APPLICATION FOR SOIL INVESTIGATION

SOIL INVESTIGATION REPORT

SITE EVALUATION FOR
INDIVIDUAL SEPTIC TANK SYSTEM
WITH SUBSURFACE,
[illegible]
EFFLUENT IRRIGATION

DIAGRAM OF PROPERTY

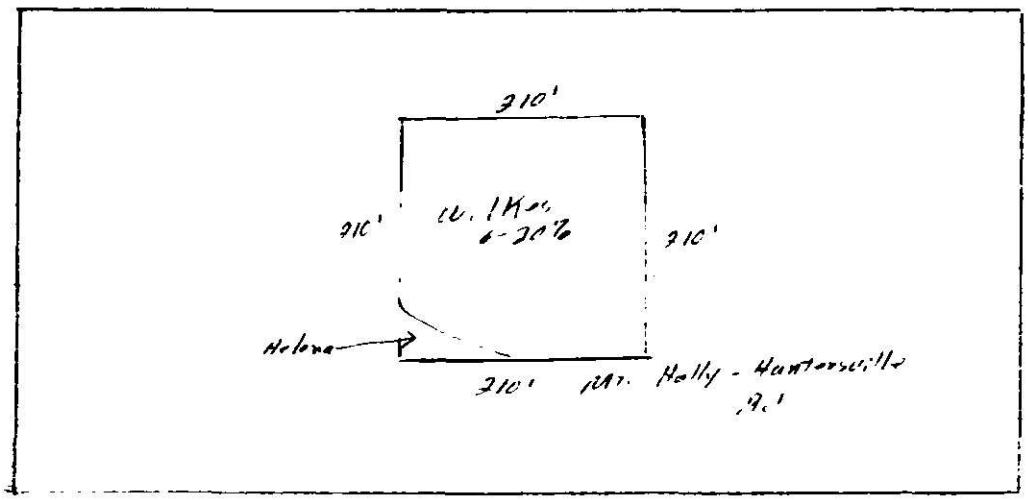
Soil Properties	Soil 1	Soil 2	Soil 3	Soil 4
1. Soil Series	Helena	[illegible]		
2. Soil Slope	Suitable 0-2%	Suitable 6-20%		
3. Soil Depth	Suitable 40"	Unsuitable 24"		
4. Soil Texture	unsuitable 2:1 Expanding clay	unsuitable 2:1 expanding clay		
5. Soil Structure	unsuitable Massive	unsuitable Massive		
6. Restrictive Horizons				
7. Soil Drainage	unsuitable Perched water table	unsuitable Seasonal high water Movement		
8. Soil Permeability (Percolation Rate)	unsuitable Slow 72+ min/in	unsuitable Slow 72+ min/in		
9. Other		Soil underlain by weathered Rock at Depth 36"		
10. Overall Rating	unsuitable	unsuitable

Remarks Recommendations Based on the investigation, the soil will not be considered suitable for installation of septic tank system.
